Change Notification

Change No.: PCN20171116XT

- FN3410 (380A...710A), open frame, IP23 and IP54
- FN3411 (380A...710A), open frame, IP23 and IP54
- FN3412 (380A...590A), open frame, IP23 and IP54
- FN3413 (380A...590A), open frame, IP23 and IP54
-

Please refer to below pictures which show old and new cable shoe:

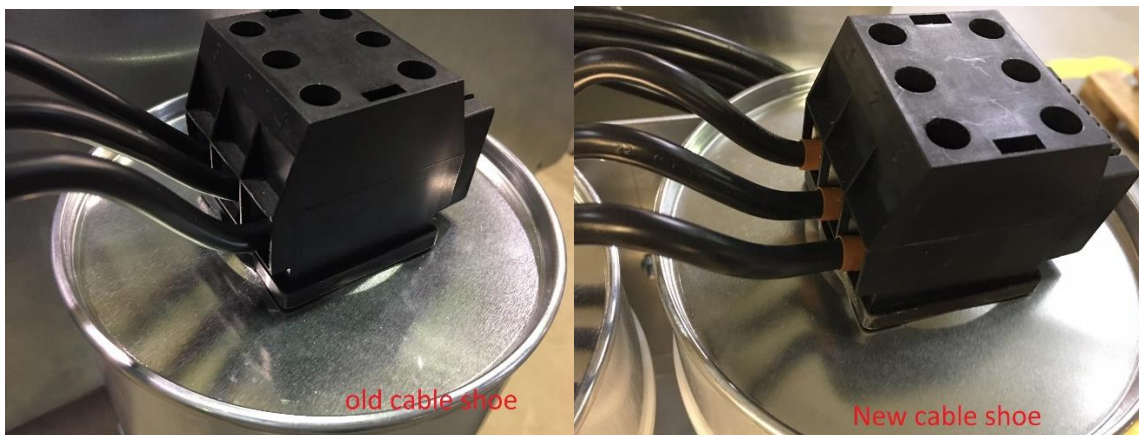
Following ongoing quality improvements, the above-mentioned product families are applied with new cable shoes increasing reliability of the capacitor terminals. The change is only visible for open frame filters (IP00), not visible for enclosed version (IP23 and IP54) filters.
